ANN ARBOR HISTORIC DISTRICT COMMISSION

Staff Report

ADDRESS: 423 West Liberty Street, Application Number HDC14-199

APPLICATION: The applicant seeks after-the-fact HDC approval to replace the wood decking on the open front porch with azec decking in the same width.

423 West Liberty (on the left) prior to renovations

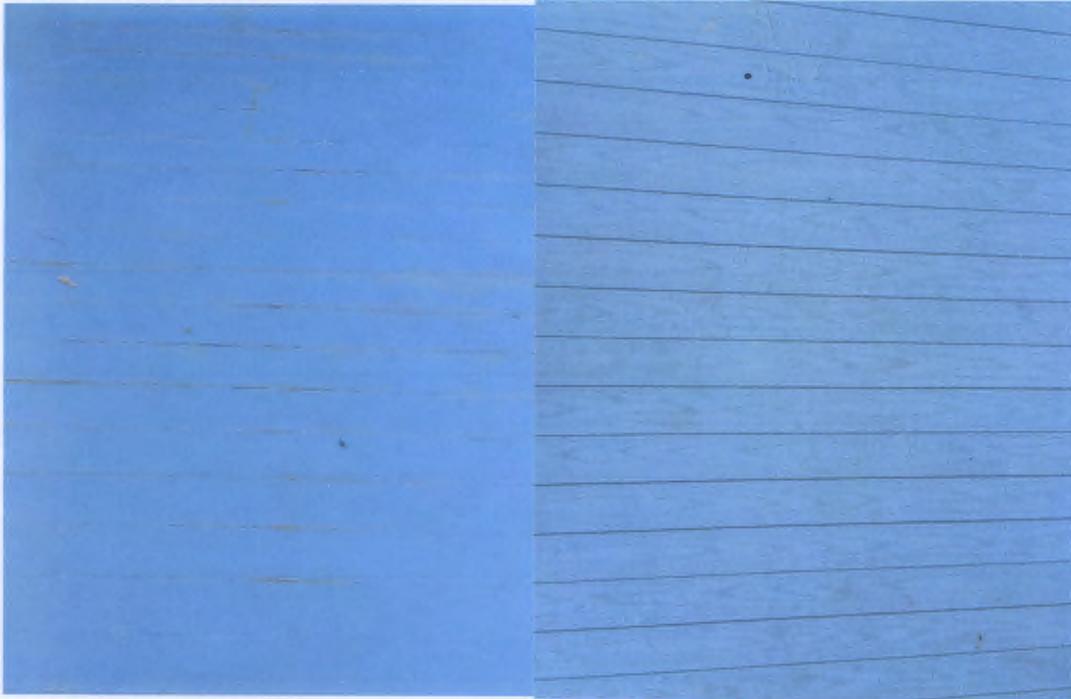
1. The owner of this condominium replaced only the front porch decking (the guardrails, posts, and stairs were reused) on this un-roofed porch because of safety concerns about the condition of the deck boards. No building permit or HDC applications were submitted before construction was undertaken. The deck boards were previously wood, in traditional dimensions, with a closed butt joint, as found on most historic wood porches. Instead of using wood, the homeowner substituted azek in a width that matches the wood decking. A citizen who was walking by and saw the work being done called and reported the work to staff.

2. The *Secretary of the Interior's Standards and Guidelines*, and the *City of Ann Arbor Design Guidelines* are clear that matching the original material is the best course of action when undertaking repairs. The SOI Guidelines for entrances and porches also include in the recommendations "limited replacement in kind--or with compatible substitute material--of those extensively deteriorated...parts". The HDC must decide whether Azek is a compatible substitute material for this porch.

3. A covered front porch originally spanned the entire front of the house, across both units, though it did not wrap around the west corner as it does now. At some point after 1931 the roof over 423 was removed. Since the porch is not covered, staff understands the desirability of an artificial deck material that can withstand water. From the sidewalk, the Azek looks compatible. Up close, it unfortunately has a stamped woodgrain design, but that's not apparent until you're standing on it. Because of the unique circumstances of this unroofed front porch, staff believes that the Azek installed is a compatible material. In the event that the porch roof is ever reconstructed, the decking should be returned to wood.

I move that the Commission issue a certificate of appropriateness for the application at 423 West Liberty Street, a contributing property in the Old West Side Historic District, to replace the wood decking on the open front porch with Azek decking in the same width, as proposed. The work is compatible in exterior design, arrangement, materials, and relationship to the house and the surrounding area and meets the *City of Ann Arbor Historic District Design Guidelines* for porches, and *The Secretary of the Interior's Standards for Rehabilitation and Guidelines for Rehabilitating Historic Buildings*, in particular standards 2 and 9 and the guidelines for Entrances and Porches.
